Report: TAB Punchlist
Function: Test, Adjust, & Balance
Date: 02/18/2025
Completed By: National TAB

PROJECT
02-17-25 CULVERS ALMA, MI

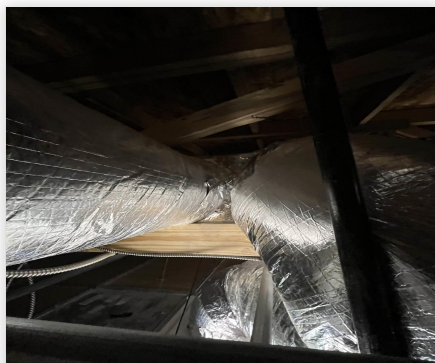
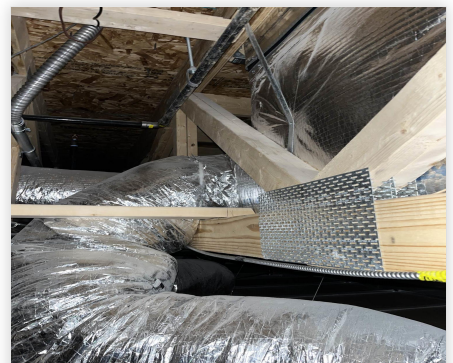
Issue Name : Missing dampers on RTU-2 (Kitchen)
Description : Diffuser 1-3,1-11,1-12 missing dampers. 1-3 is high on flow at 452/350CFM 1-11 is very high on flow at 753/350CFM unable to reduce airflow to these diffusers. Diffuser 1-12 was able to be restricted with duct straps to bring flow to design. Recommend Mechanical Contractor install dampers so these diffusers can be sufficiently balanced.
Created By : National TAB **Assigned To :** National TAB - Dylan Crisman
Status : Open
Priority : High **Asset Tag :**
Originated Date : 02/18/2025 - Dylan Crisman - National TAB

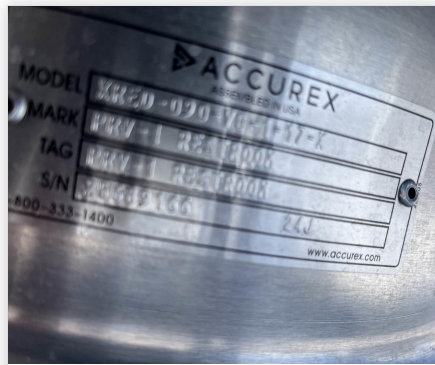
Issue Name : PRV-1 RR Exhaust not operational
Description : PRV-1 Restroom Exhaust fan is not operational. Getting voltage at the breaker as well as at the fan but fan will not operate, motor will not kick on. Recommend electrician/mechanical inspection to diagnose problems with PRV-1.
